HISTORIC LANDMARK COMMISSION PERMITS IN NATIONAL REGISTER HISTORIC DISTRICTS

MAY 22, 2017 NRD-2017-0036 812 Theresa Avenue West Line Historic District

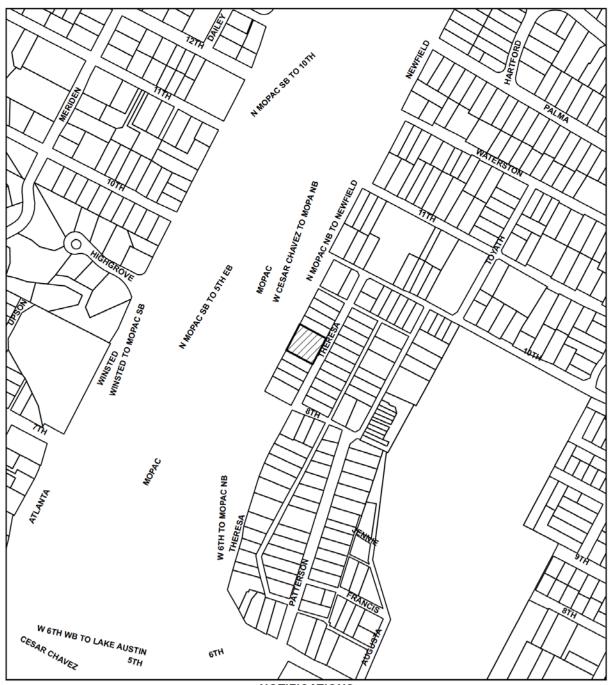
The West Line Historic District has no design guidelines for new construction. General design principles for new construction in historic districts encourage using the contributing buildings as the model for size, scale, materials, roof forms, and fenestration patterns. The existing house on this site, while in a very deteriorated condition, was a very good example of a Craftsman bungalow, and should be used as a reference for new construction.

Strongly encourage the applicant to design the new structures in a style more compatible with the contributing buildings in the district. The original house on this site was 100% compatible with the character of the district; the proposed new construction is at the other end of the spectrum, and while using traditional-looking materials and gabled roof forms, will stand out and possibly detract from the historic character of the district.
